**TOWN OF LOS GATOS
PLANNING COMMISSION
REPORT**

DATE: May 7, 2021
TO: Planning Commission
FROM: Joel Paulson, Community Development Director
SUBJECT: Requesting Approval for Demolition of an Existing Single-Family Residence and Construction of a New Single-Family Residence on Property Zoned R-1:8 Located at 140 Arroyo Grande Way. APN 424-23-048. Architecture and Site Application S-20-013. Property Owner/Applicant: Yogesh Jhamb. Project Planner: Sean Mullin.

RE: Plan Updates – 140 Arroyo Grande Way (S-20-013)

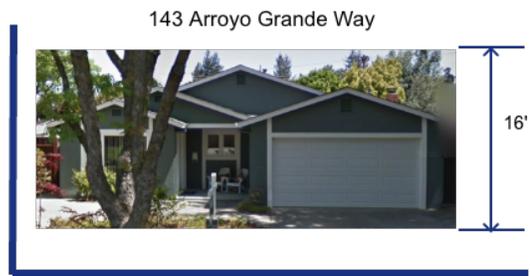
1. Reduce Mass and Bulk of New Home

We have changed the design and pitch of the roof to achieve a 6' reduction in the height of the home. The height of the home has been reduced from 21'-10.5 to 15'-11.5". The comparison between the design originally submitted and the latest design is depicted in the image below.

In addition to reducing the height of the new home, we have also done the following:

- Simplified the roof forms by replacing the garage gable roof with a hip roof.
- Incorporated consistent window forms of all elevations.
- Removed the roof dormer.
- Lowered the roof eaves by 1'.

RIGHT SIDE ELEVATION

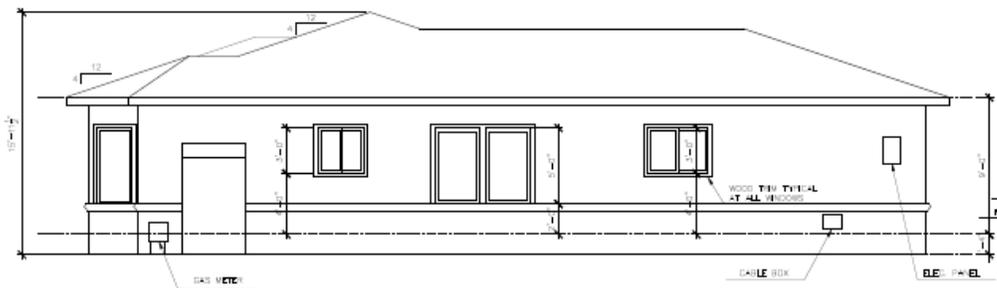
- b. Privacy: We value the privacy of our neighbors. We have lowered all windows by 1' to address the privacy concerns of our neighbors. The neighbors at our back are at a 2' higher grade level, which effectively makes the fence 8' tall (see image below). We have explained this to our neighbors at the back and they have not raised any more concerns.

We have highlighted to our side neighbors that there is no way for us to look over the 7' fence standing at the floor level, as shown below. We have a 6' fence on one side, and we are willing to share the cost of increasing the height to 7'.

We have limited the number of windows on both the side elevations. The right elevation has only one bedroom window and the remaining two are bathroom windows.

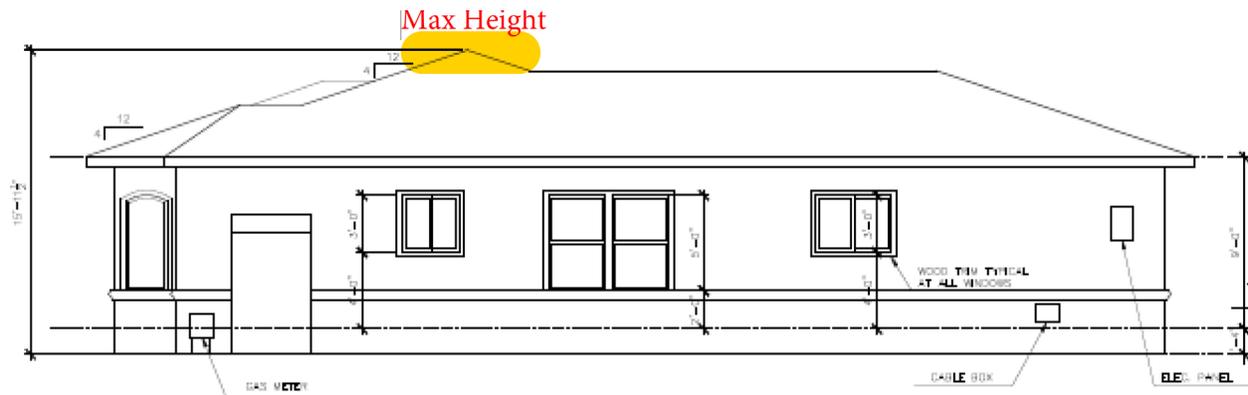
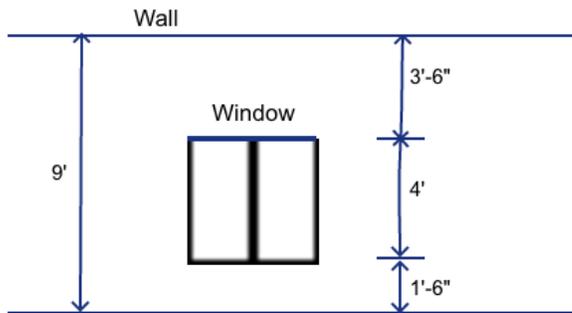
"Lower windows - we appreciate your reducing your windows, but the fence and our top-down/bottom-up blinds mitigate our privacy concerns if you would like to raise the windows back up."

The bedroom window on our side elevation towards your home does not align with any of your windows. The remaining two windows are bathroom windows, which will have no visibility. We have attached an image that indicates how a 4' window would look with the top of the window at 5'-6" from floor level to be aligned with the top of the fence at 7'. As you can see, this results in the window being too low on the wall. We hope you can understand that we value your privacy and that there is no way for us to look over the fence standing at the floor level.

RIGHT SIDE ELEVATION
1/4" = 1'-0"

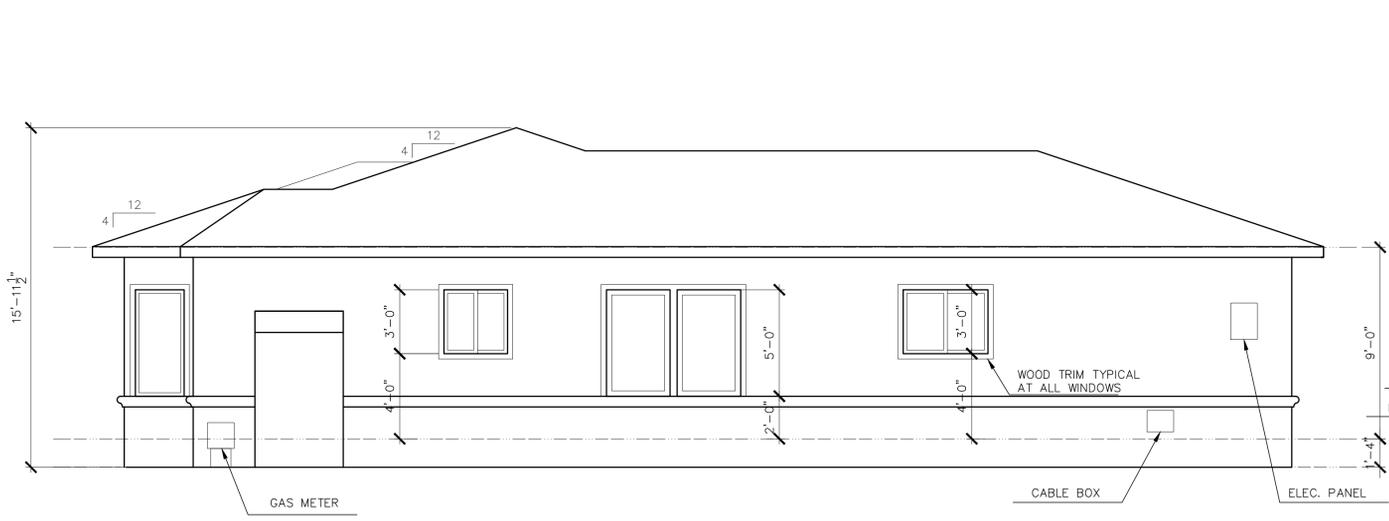
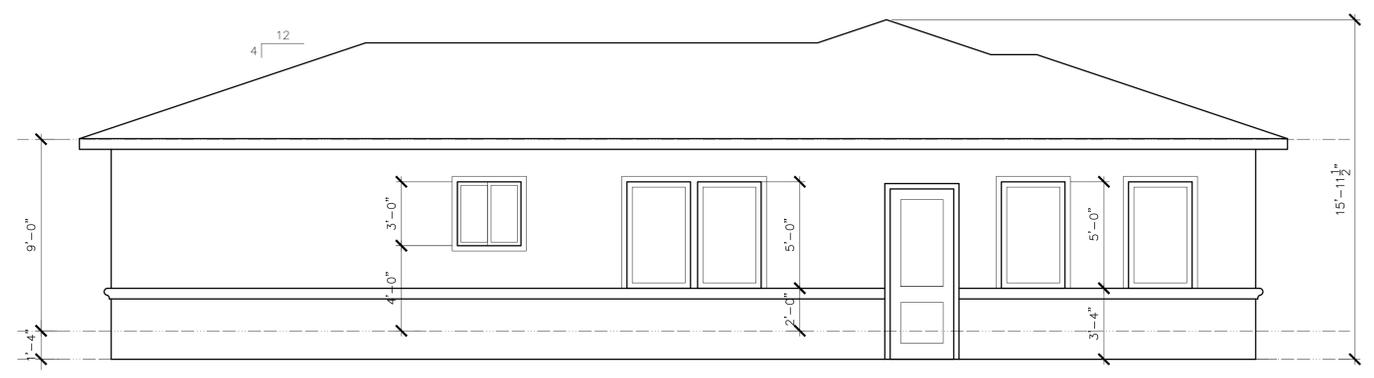
1. Lower the roof eave height as much as possible. The recommendation illustrations show a one-foot decrease in height.

2. Utilize a hip roof on the garage in lieu of the proposed gable.

6. Remove the roof dormer to simplify the roof.

The applicant has lowered the plate height and corresponding eave height by one foot.

The applicant has changed the gable-end roofs over the garage and at the rear of the residence to hip roofs.

The applicant has eliminated the roof dormer.
